### DEVELOPMENT CONTROL PANEL

**When: 19:00hrs – 22 JULY 2021**

**Application Number:** 21/01288/FUL

**Description:** Two-storey side and rear single storey extension (part-retrospective, re-submission of 21/00604/FUL)

# Proposed Elevations

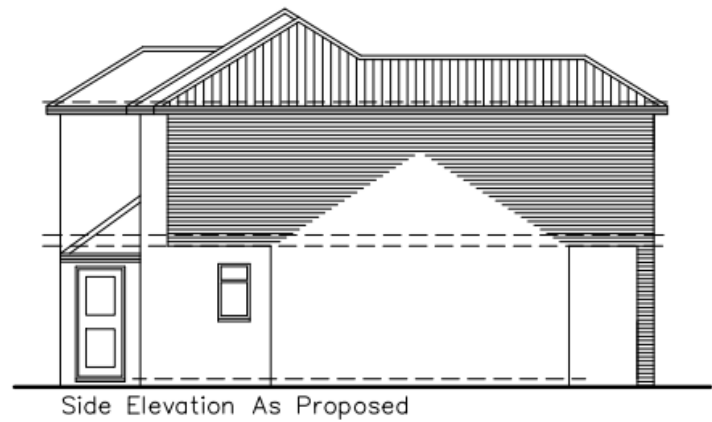
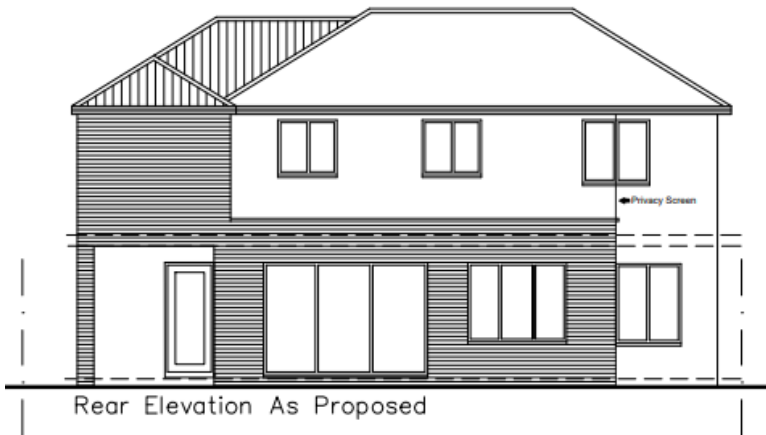
A question was raised with MKC planning case officer re plans inaccuracy which was not welcomed by the applicant as he feels that he has made amendments to the build at the request of GLPC. The elevations for side and front do not match with the ground floor plan.

Condition: The Front elevation is cantilevered, and the ground floor front does not increase (not indicated on plans submitted)

- 7.17 The condition requested by Great Linford Parish Council to retain the cantilevered front elevation, in order to retain parking, is not necessary, as any permission would be granted in accordance with the approved plans only. Such a condition would be unreasonable and unnecessary in this regard. Any future works forward of a wall forming part of the front elevation would require express planning permission and would be assessed under a planning application.

## Privacy Screen

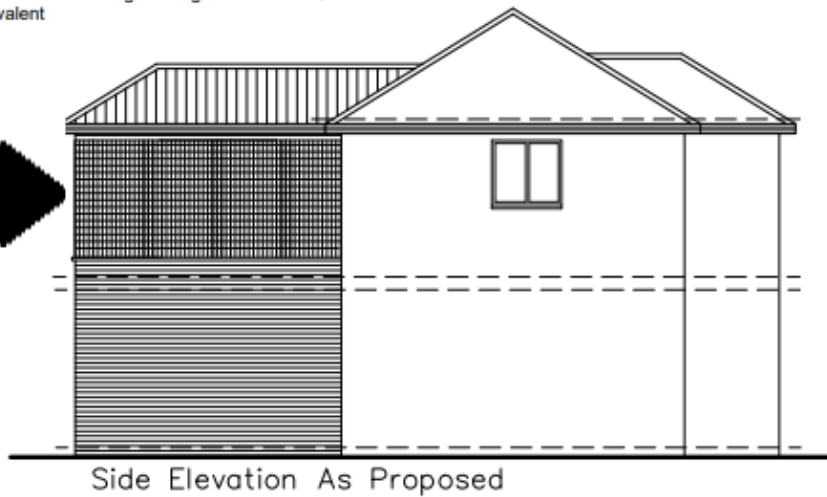
- 7.8 The main concerns that have been raised relate to the suggested loss of privacy resulting from the proposed Juliet balcony, loss of sunlight and loss of visual outlook. The most recent application was designed so the Juliet balcony would have had a direct view to the rear windows of No.4 Brockhampton. However, the current proposal includes the addition of a proposed obscure-glazed privacy screen, which in this case is considered to mitigate the privacy concerns. A condition is recommended to require its provision prior to first occupation of the first-floor bedroom where the Juliet balcony is located, and to prevent its later removal or alteration to other glass, in order to preserve amenity for the neighbours.

- 7.13 The single storey rear extension would be located between 1.3 metres and 3 metres from the boundary with No.4 Brockhampton, and approximately 14.1 metres from the neighbouring rear elevation. It is not considered that the rear extension, by virtue of its relatively modest height, would result in overshadowing or a significant loss of visual outlook to this neighbour. The most recent application was refused due to the unobstructed views that would be afforded by the proposed Juliet balcony (on a side elevation of the two-storey rear projection) into the rear habitable room windows of no. 4. It was deemed that this would have a detrimental impact on the privacy currently enjoyed by the occupants of that property. Therefore, the privacy screen is considered to be necessary to allow the proposal to be acceptable in terms of residential amenity, and it is considered by officers to be a satisfactory solution to overcome the reason for refusal of the most recent previous application,, and is recommended to be secured by condition.

3. The privacy screen as shown on the approved plans shall be constructed and implemented in accordance with these details prior to the first occupation of the first-floor bedroom served by the Juliet balcony, and thereafter be retained in accordance with the specifications set out on drawing no. 2020/0080/0001 Rev D.

1.8m height x 3.9m width Obscure Glazed Minimum level 3 within the Pilkington range of Textured Glass or equivalent
